Access Compliance Report

Public Rights-of-Way

(Curb Ramps)

Intersection ID: 2412	Main Street: HIDDEN_MEADOW_LN	Cross Street: LAUREL_RUN_DR	Location: W
ADA ID: E12BC88BD16A	Ramp Type: PerpDiag	Initial Pass/Fail: Fail	Overall Compliance: No
Severity Score: 12.5			
Codes/Mitigation Info/Possible Solution		Field Measurements/Component Compliance

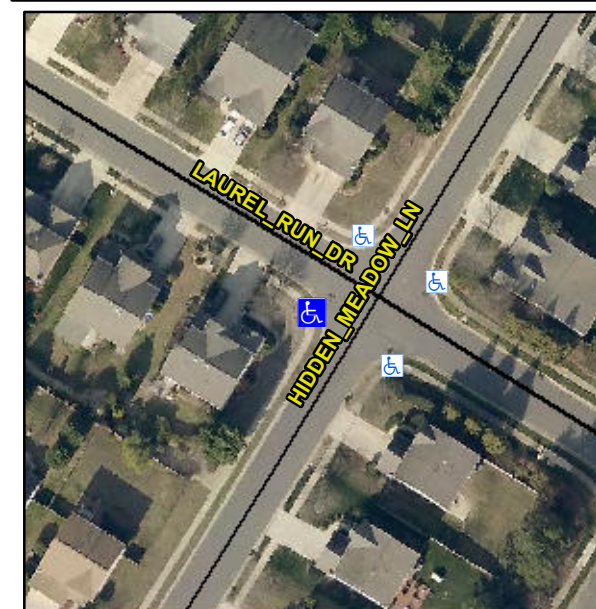
Not Found, R304.2.2

Compliance	Description	Data	Compliance	Description	Data
N/A	Ramp Length (in)	53.0	No	Ramp Slope (%)	10.3
Yes	Ramp Width (in)	48.0	Yes	Ramp XSlope (%)	1.3
N/A	Flare Type LT	N/A	N/A	Flare Type RT	N/A
N/A	Flare Slope LT (%)	N/A	N/A	Flare Slope RT (%)	N/A
N/A	Flare Traversable LT?	N/A	N/A	Flare Traversable RT?	N/A
N/A	Landing Length (in)	N/A	N/A	DWS Provided?	N/A
N/A	Landing Width (in)	N/A	N/A	DWS Contrast?	N/A
N/A	Landing Slope (%)	N/A	N/A	DWS Length (in)	N/A
N/A	Landing X Slope (%)	N/A	N/A	DWS Full Width?	N/A
N/A	Landing Curb? (Y/N)	N/A	N/A	DWS Offset (in)	N/A
N/A	Shared Landing?	N/A			
N/A	Gutter Ponding?	N/A	N/A	Gutter Slope (%)	N/A
N/A	Gutter Lip Ht (in)	N/A	N/A	Gutter X Slope (%)	N/A
N/A	Painted X Walk1?	No	N/A	Painted X Walk2?	No
	X Walk 1 Direction	To SE		X Walk 2 Direction	To NE
N/A	X Walk 1 Width (in)	N/A	N/A	X Walk 2 Width (in)	N/A
	X Walk 1 Slope (%)	6.6		X Walk 2 Slope (%)	2.2
	X Walk 1 X Slope (%)	1.2		X Walk 2 X Slope (%)	5.3

N/A	Ramp inside XWalk1?	N/A	N/A	Ramp inside XWalk2?	N/A
	Road Slope (%)	3.3	N/A	Clear Space?	N/A
	Road X Slope (%)	5.3	N/A	Clear Space to XWalk (in)	N/A
N/A	Any Obstructions?	N/A	N/A	Storm Grate/Utility Hazard?	N/A
	Obstruction Type			Storm Grate/Utility Type	
		N/A			N/A
			Yes	Surface Condition? (G/P)	Good

Remove & Replace Curb Ramp With Two New Directional Ramps or Equivalent.
